UNITED STATES PATENT AND TRADEMARK OFFICE

Office Action Summary

10/728,892

DETAILED ACTION

FIG. 28

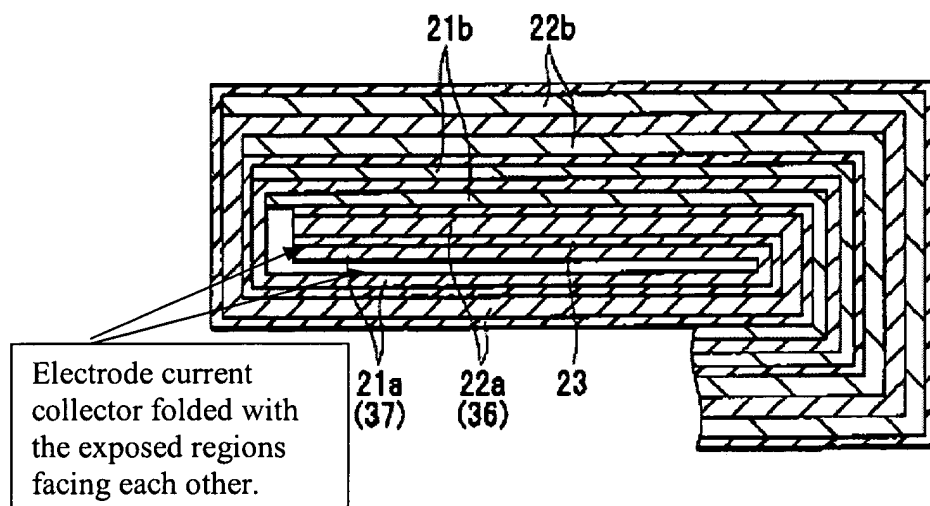
With respect to claims 5 and 12, Shibamoto further discloses the current collector (21a) is folded in upon itself such that any burrs that occurred from the manufacturing process will come in contact with the same material (Figure 28).

With respect to claims 21-24, Shibamoto discloses the folded portion is provided on the cathode where the uncoated portions are formed on both sides (37, double sided exposed portion) of the electrode plate and the exposed portions face each other (as seen in Figure 28 above).
